A. Request approval of Payment Request No. 18 to SER Construction Partners, LTD. for the Construction of DHS 0-7 (0.90 miles).

C. Request approval of Change Order No. 44 and No. 45 on the Contract with SER Construction Partners, LTD. for the Construction of Levee DHS 0-6BC. Subject to Department of Homeland Security (DHS) concurrence.

CHANGE ORDER NO. 44

Reference: LEVEE IMPROVEMENTS PROJECT
DHS SEGMENT 0-6B & O-6C (1.38 MILES)

WALL BUILDUP DETAILS

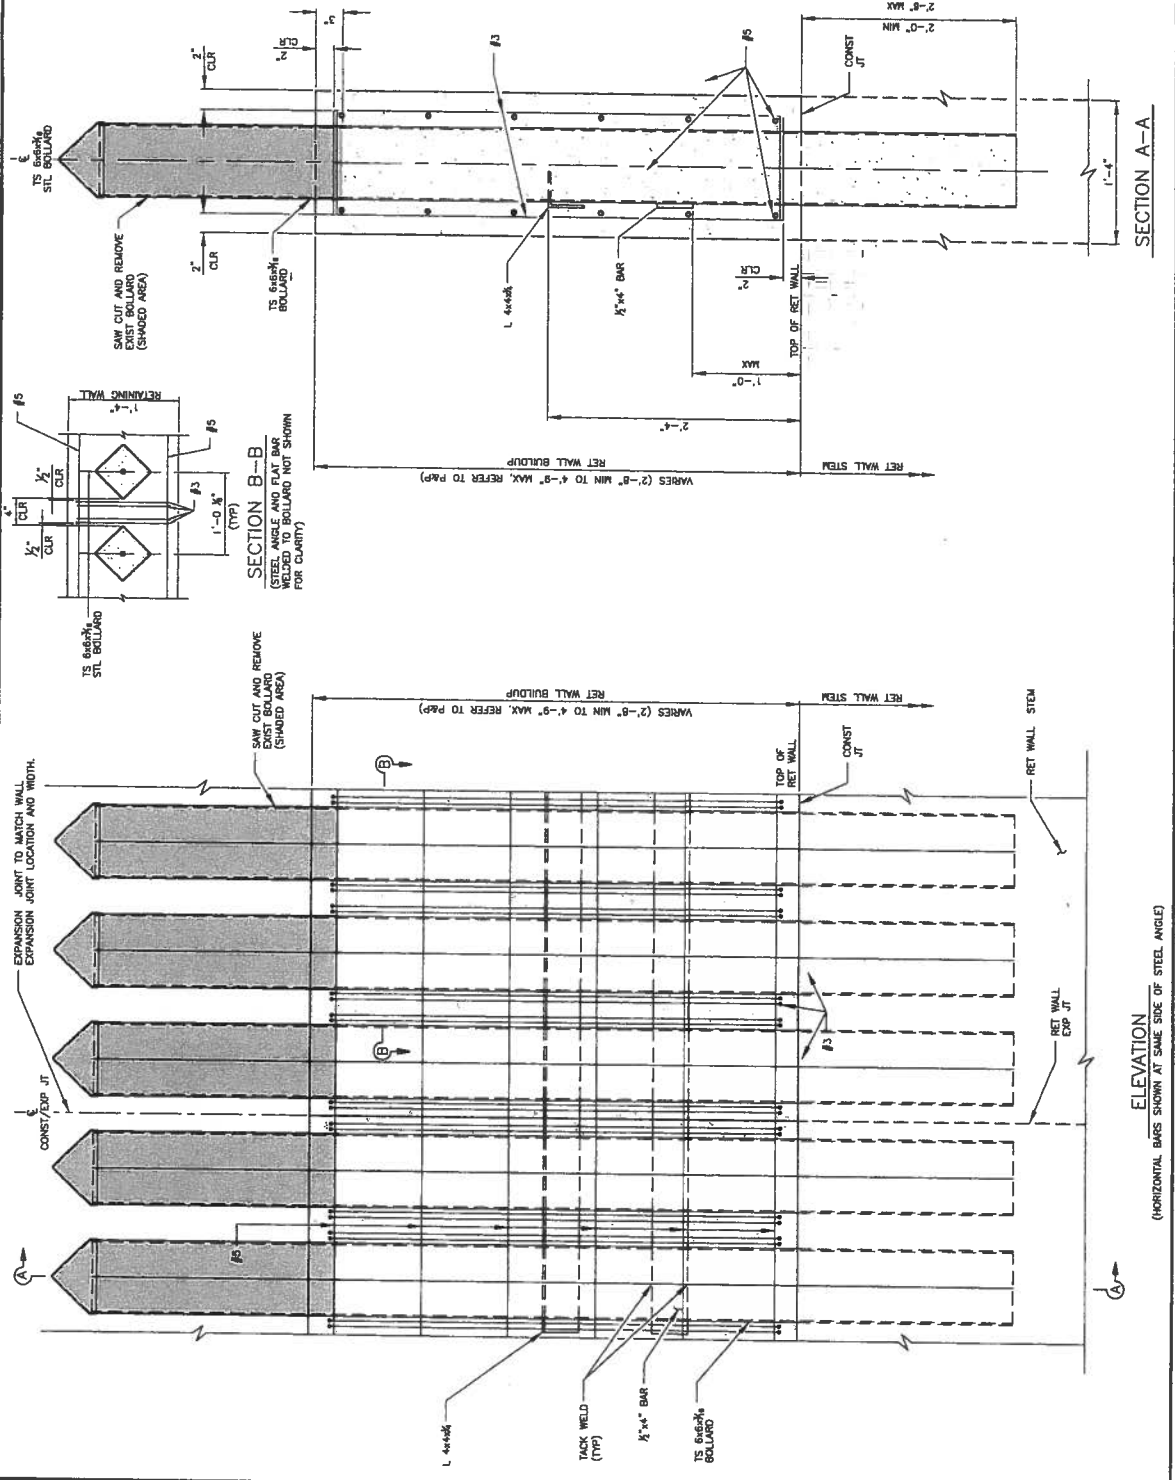
Extend height of concrete retaining wall by encasing bollards in concrete.

Description: Extend height of concrete retaining wall by encasing bollards in concrete.

- NOTES:**
- REFER TO PLAN AND PROFILE SHEETS FOR DIMENSIONS. ALL BOLLARDS ARE TO BE CUT AND REMOVED.
 - ALL BAR DIMENSIONS ARE TO CENTERLINE OF BAR UNLESS NOTED OTHERWISE.
 - ALL REINFORCING BARS SHALL BE IN ACCORDANCE WITH ASTM GRADE 60, fy=60 ksi.
 - CONCRETE TO BE CLASS "C" fc = 3000 PSI.
 - CONTRACTOR SHALL CLEAN TOP OF WALL CONCRETE SURFACE THAT IS IN CONTACT WITH NEW BUILD UP BEFORE THE PLACING OF FORMS. ALL REINFORCING NEW CONCRETE TO BE PLACED, AND CONSTRUCTION NEW CONCRETE TO BE CURED AND STANDING WATER REMOVED.
 - BEFORE STARTING WORK, OBTAIN APPROVAL FOR PROPOSED CONSTRUCTION METHOD FROM RESIDENT PROJECT REPRESENTATIVE.
